**TOWN OF BROOKLYN
PLANNING AND ZONING COMMISSION
NOTICE OF PUBLIC HEARING**

SD 21-004: Resubdivision Application to create two building lots at Almada Drive and Paradise Drive (Assessor's Map 21, Lot 6), 104 acres, RA Zone, Applicant: Paul Lehto.

ENGINEERING PLAN REVIEW PERTAINING TO A 2-LOT RESUBDIVISION (ASSESSOR'S MAP 41, LOT 47) 40 ALMADA DRIVE BROOKLYN, CT (May 3, 2021)

Existing Conditions Plan

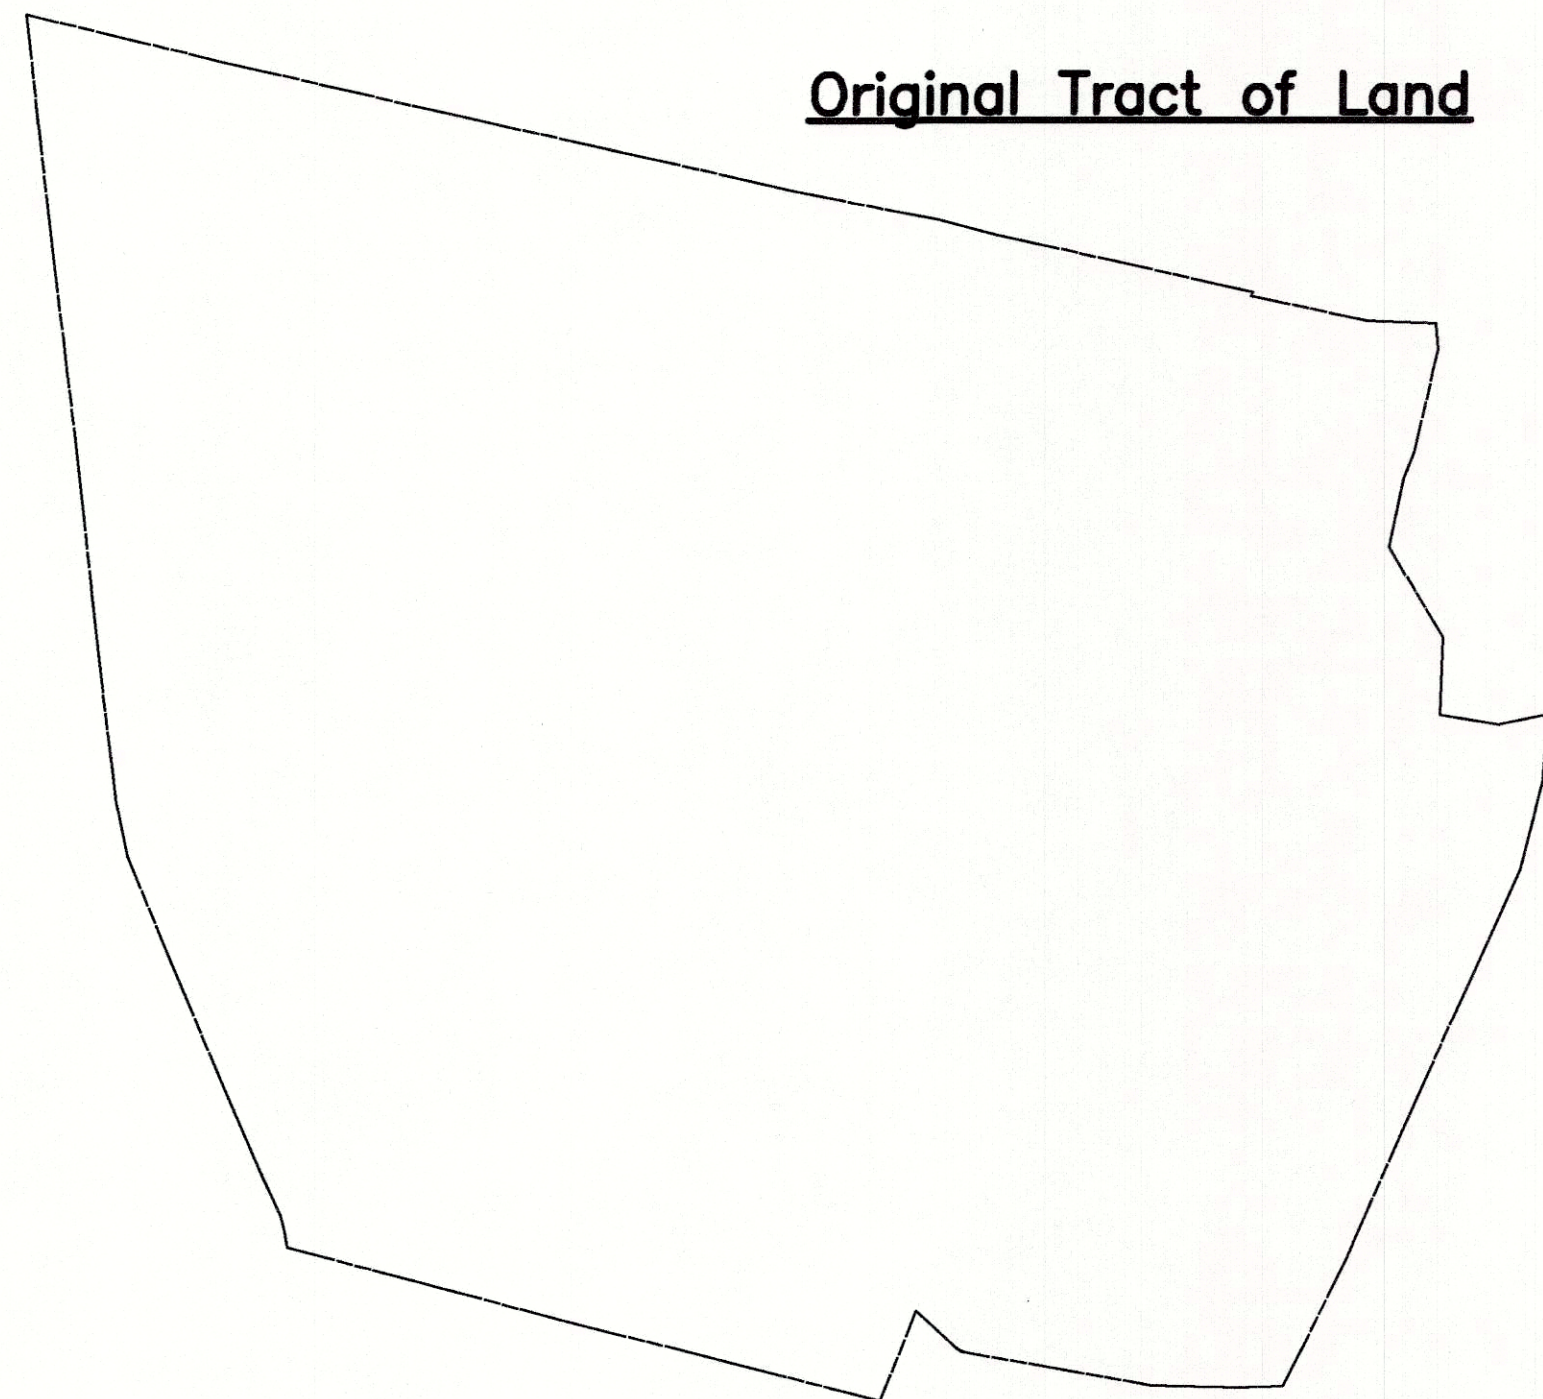
3. The wetlands delineations on the plan have been certified as being delineated by R.C. Russo with his “signature” on the plan. When did Mr. Russo flag the wetlands as no flags were visible from Paradise Drive for the 7-X line when a site visit was made on April 30, 2021?

4. Since this plan was prepared November 13, 2021, has the abutter's list been verified as being accurate as of May 3, 2021? Why have abutters on the west side of Paradise Drive opposite the land being resubdivided been omitted (see subparagraph 2.10 under Section 4.2 of the Brooklyn Subdivision Regulations)?

Comment has not been addressed.

Comment has been addressed.

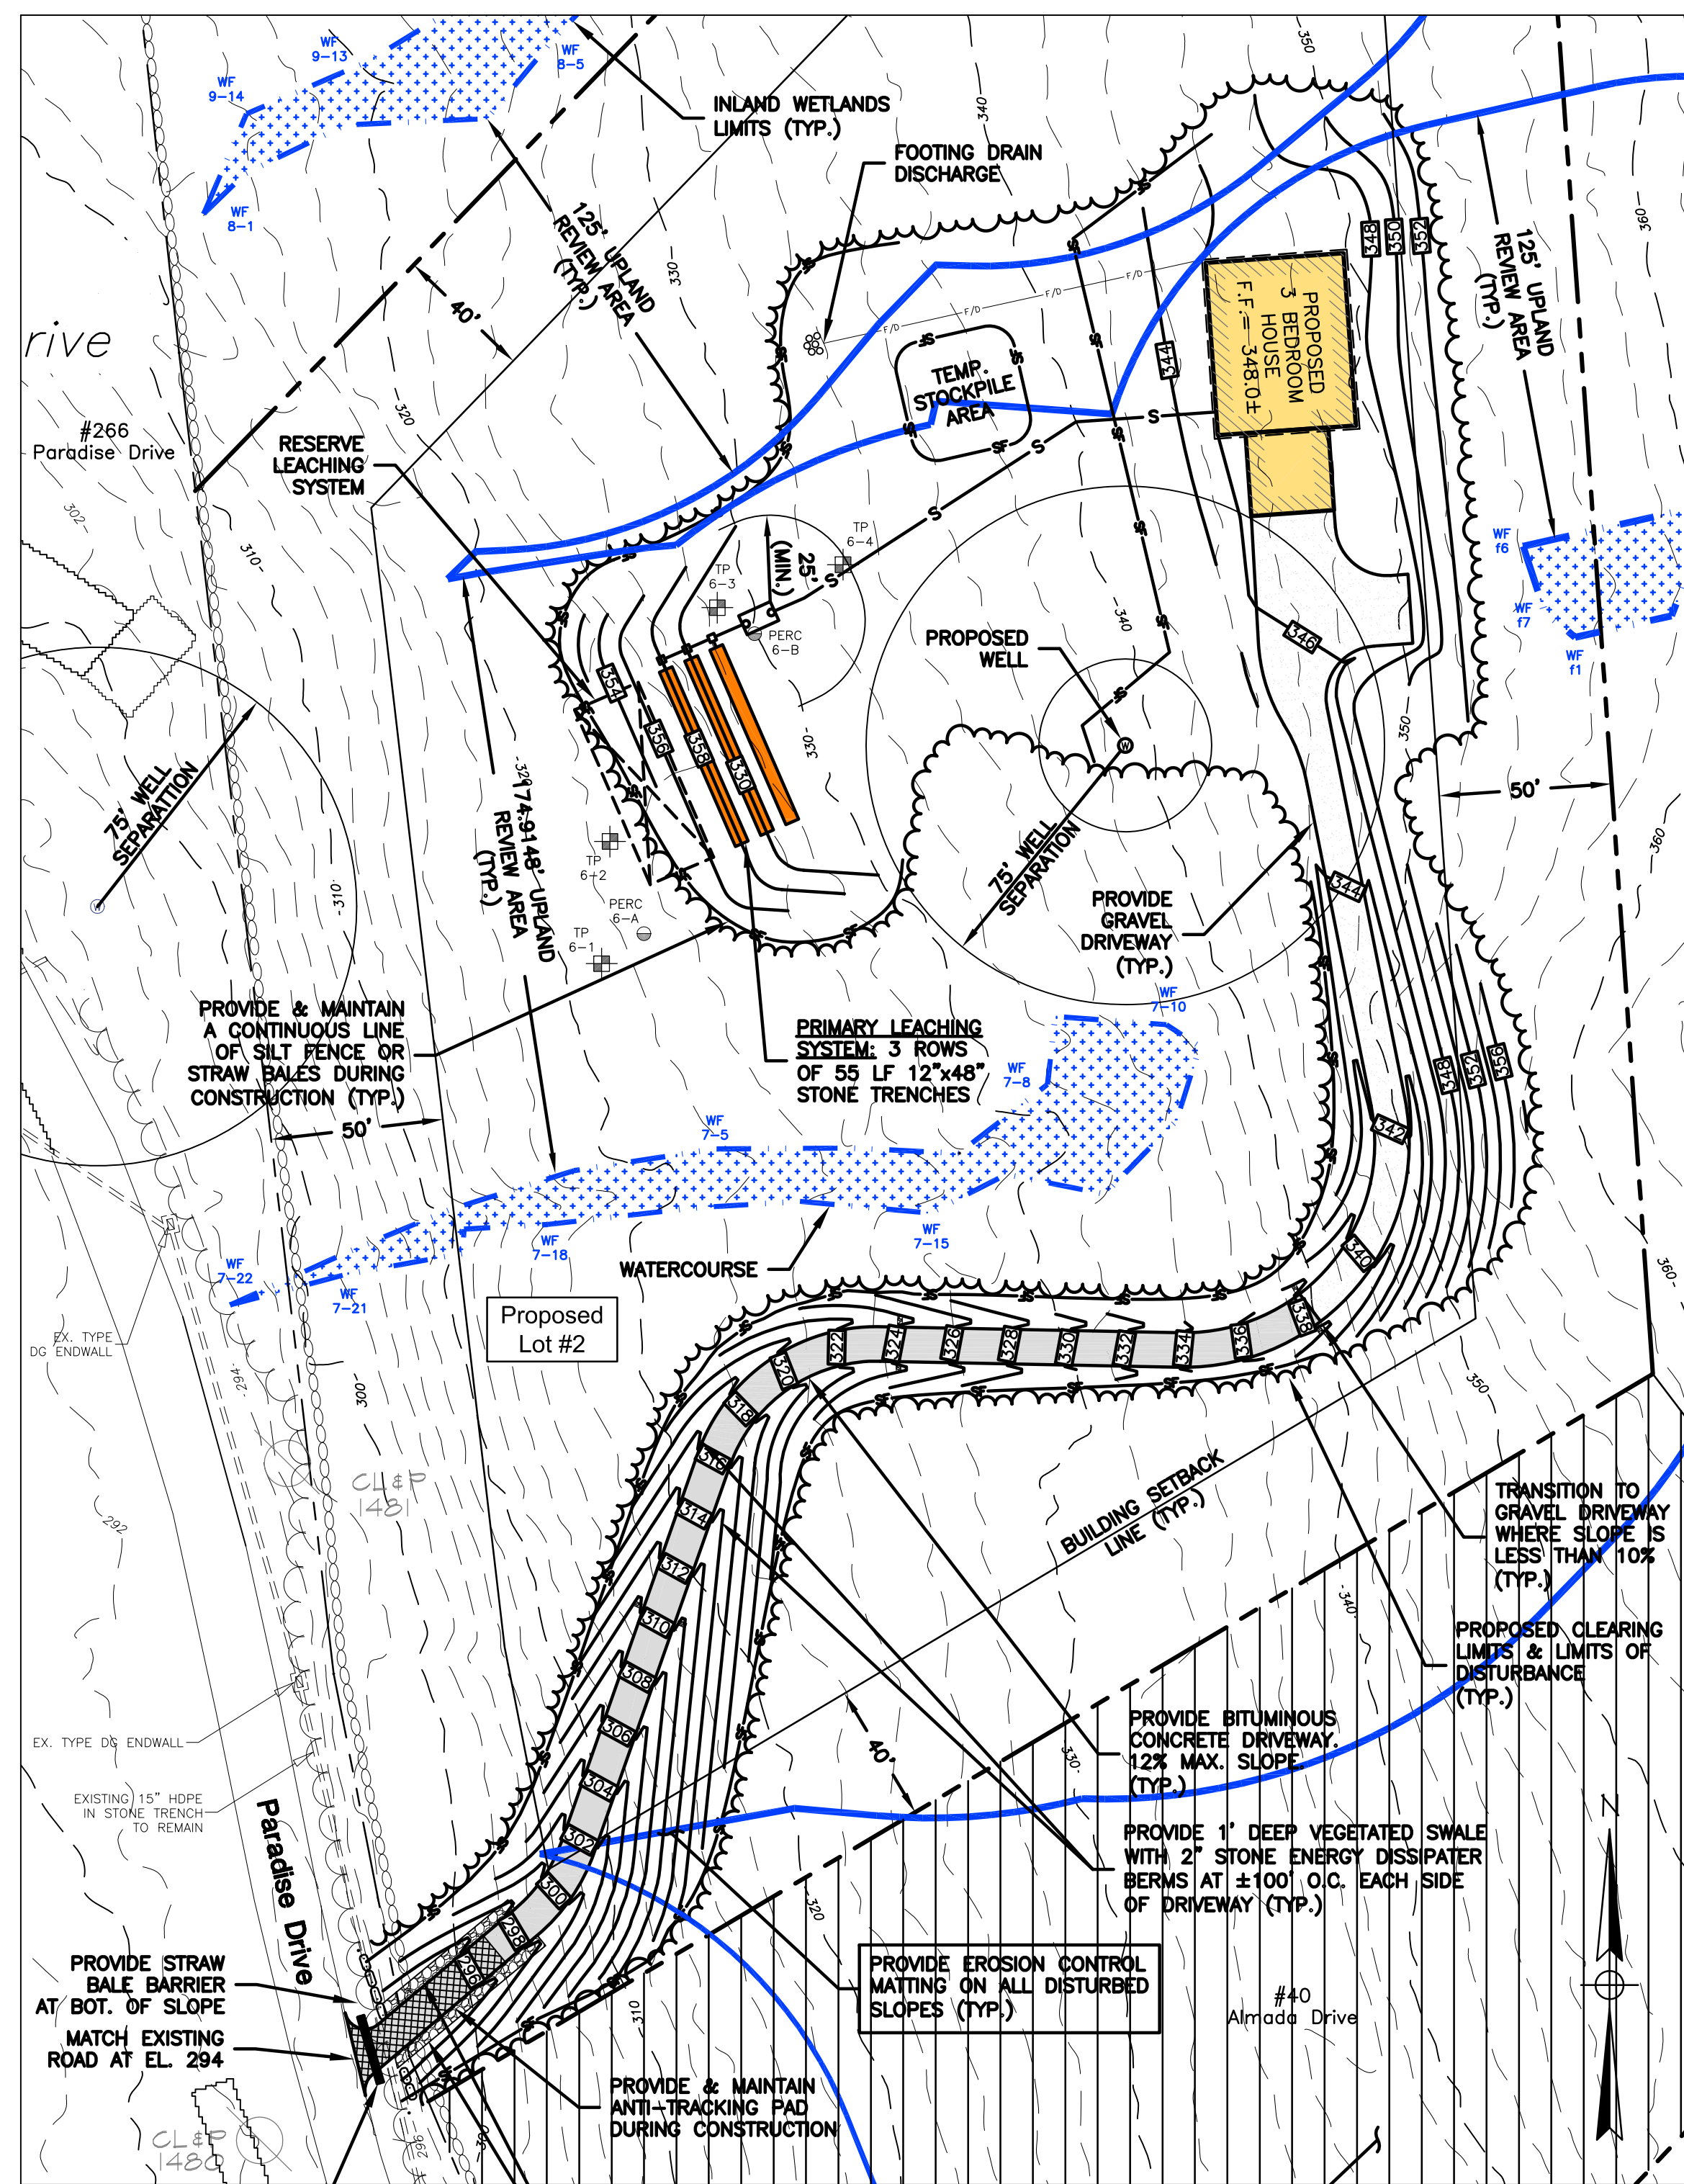
Considering these observed conditions, the proposed paved driveway needs careful consideration with respect to the proposed cuts that remove more than 24" of existing soil to form new slopes.

2. There is no indication on the plan for the conveyance of water in the existing Paradise Drive swale to pass under the apron of the proposed driveway. This needs to be evaluated with drainage calculations submitted for review.

3. Due to the steepness of the Lot 2 driveway gradient and it also being paved, formal drainage swales with velocity attenuators need to be located along both edges of the driveway from Elevation 242 down to Paradise Drive. This is to help guard against degradation of the existing drainage swale, especially during heavy rainfall events. A construction detail is also required.

4. It is not apparent from looking at the plan how soil erosion and sediment transport from driveway construction will minimize sediment transport to the Paradise Drive drainage swale and underground drainage system. This needs an explanation.

Comment has been addressed.

Comment has been addressed.

Comment has been addressed.

Comment has been addressed.
